**NATIONAL INSTITUTE OF
OCCUPATIONAL SAFETY AND HEALTH
ADVISORY BOARD ON DOSE RECONSTRUCTION**

***THE REVIEW OF NIOSH/ORAUT
PROCEDURES AND METHODS USED
FOR DOSE RECONSTRUCTION***

S. Cohen & Associates
McLean, VA

January 2005

Figure 2.1-3. Worker Receiving Radiation Exposure From Posterior Geometry

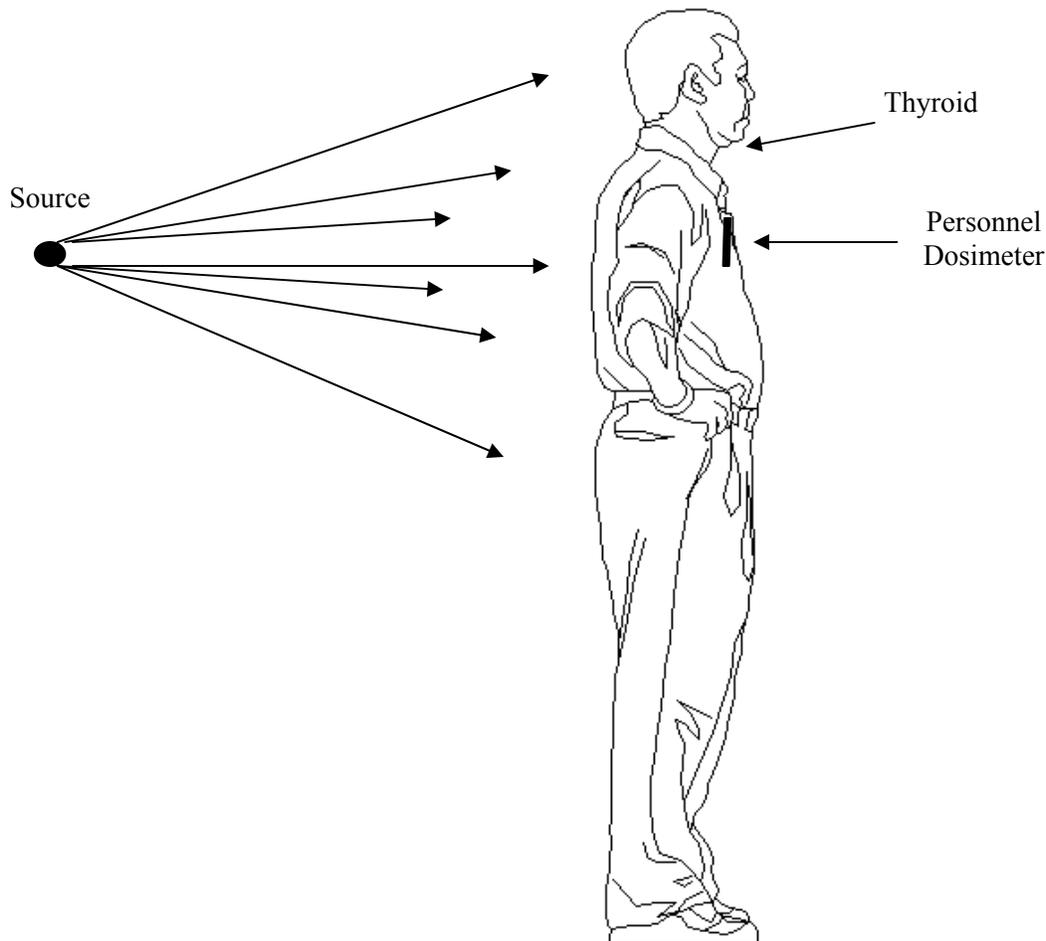
for PA geometry given in Appendix B wrongly assumed that the measured dosimeter dose was worn on the **posterior** of the torso instead of the **anterior**. The consequence of this error would be most pronounced for those tissues/organs that are located at/near the posterior surface of the body (e.g., female breast, male testes, eye, thyroid).

For example, for photons between 30 and 250 keV, Appendix B gives a thyroid DCF_{PA} value of 0.298 rem for a recorded deep dose ($H_p(10)$) of 1 rem. If the recorded deep dose involved a dosimeter (either film or TLD) worn on the chest, the assigned thyroid DCF_{PA} of 0.298 is in error, as shown in the diagram below:

- (1) the personnel dosimeter received radiation that is attenuated by the full thickness of the chest
- (2) the thyroid receives radiation that is attenuated by tissues that are limited to the neck
- (3) additionally, tissues/organs within the body would also receive exposure from **backscatter**, which would **not** be recorded on an anterior-worn dosimeter that is subjected to a PA exposure geometry

If this interpretation is correct, than DCF_{PA} values for **all** tissues should be ≥ 1.0 with the highest DCF_{PA} values for (1) low-energy radiation and/or (2) tissues/organs located near the posterior portion, since these tissues are subject to a beam that is **least** attenuated and subject to a maximum backscatter.

Figure 2.1-4. Ratio of H_E to $H_P(10)$ as a Function of Photon Energy

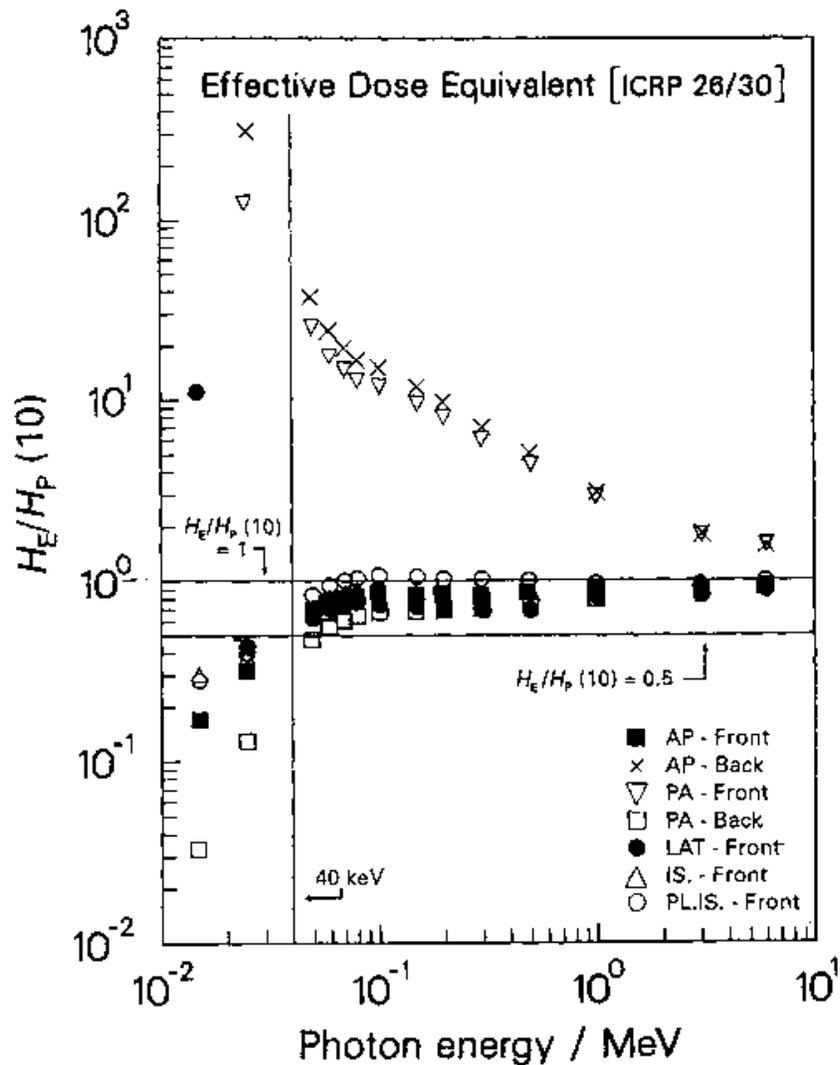
The critical difference in the $H_E/H_P(10)$ coefficient for a dosimeter that **in fact is worn on the front**, but is wrongly assumed to have been worn on the back, is dramatized by comparing the curves represented by Δ and \square . The difference is most pronounced for low-energy and low-penetrating photons. For example, for 30 keV photons in cases in which the dosimeter is worn on the back, the coefficient is about 0.14; when the dosimeter is worn on front, the $H_E/H_P(10)$ coefficient is about 100, or nearly 1,000 times higher.

As previously stated and verified in Figure 2.1-4, for all photon energies, the ratio of organ dose to recorded $H_P(10)$ must be greater than unity when the recorded dose was measured on the body's anterior and when exposure corresponds to a PA geometry.

Figure 2.1-5. Diagram to Illustrate the Meaning of Surface Backscatter and Percentage Depth Dose

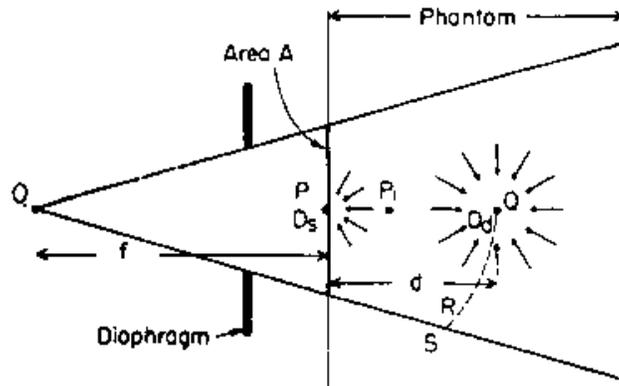
Backscatter may significantly influence the dose-response of a dosimeter and reflects the calibration protocol. Fix et al. (1994) states that "In 1984, the dosimeter calibration procedure was changed to "on-phantom" as opposed to "in-air" to better simulate the dose to workers."

Since DCFs provided in OCAS-IG-001 do not distinguish between dosimeter readings as pre- or post-1984 when the conversion of free air to on-phantom calibration took place, questions that must be raised include the following:

Figure 2.1-6. Variation of the Backscatter Factor with the Quality of the Radiation for a Number of Field Sizes
(Source: Hine and Brownell 1956)

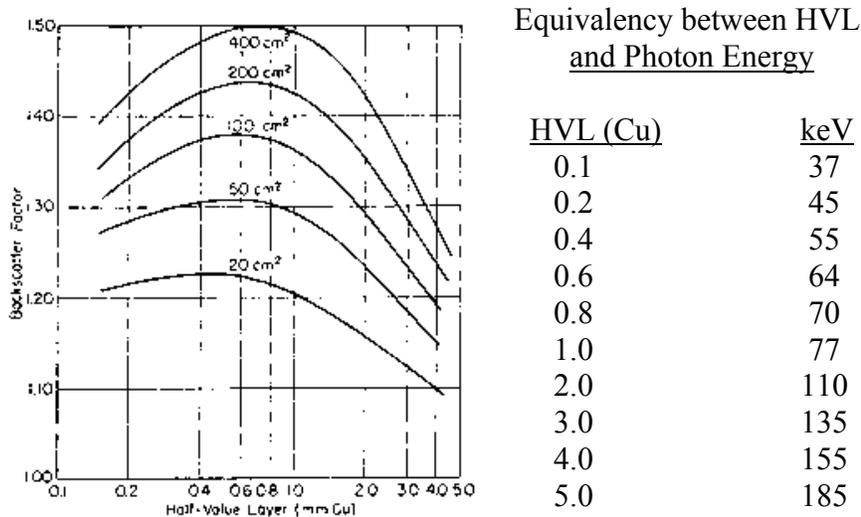
Hine and Brownell (1956) evaluated backscatter and concluded that it depends (1) in a complex way on the energy of the radiation, (2) the area of the field, and (3) thickness of the scattering medium. The percentage of backscatter may be as high as 50% for a large field, adequate thickness, and select photon energy. Backscatter factors related to radiation quality and field size are summarized in Figure 2.1-6. The data indicate that, for photons with HVL between 0.6 mm Cu and 1.0 mm Cu (or ~60 keV-80 keV), the backscatter factor for a dosimeter worn on the upper torso of an adult could reach a value of about 1.5. Such a backscatter factor would apply to DCFs with photon energies between 30 and 250 keV, as given in OCAS-IG-001.

Figure 5.2-1

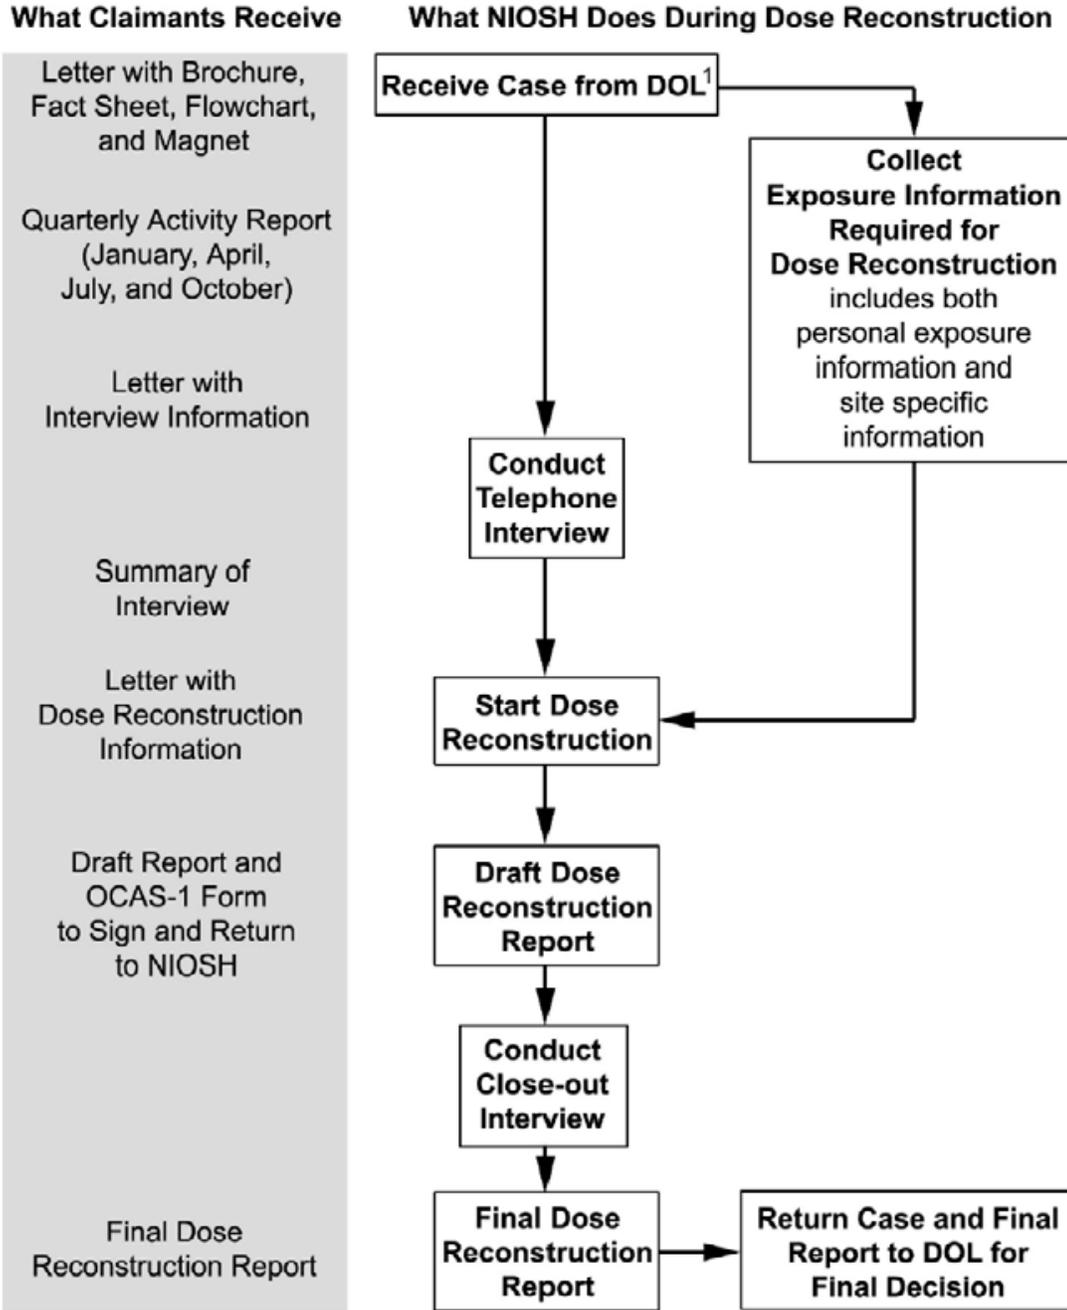
The flowsheet (see Figure 5.2-1 on page 5-5) indicates that dose records are collected in parallel with the interviews. Hence, no connection appears to exist between the two steps. Further,
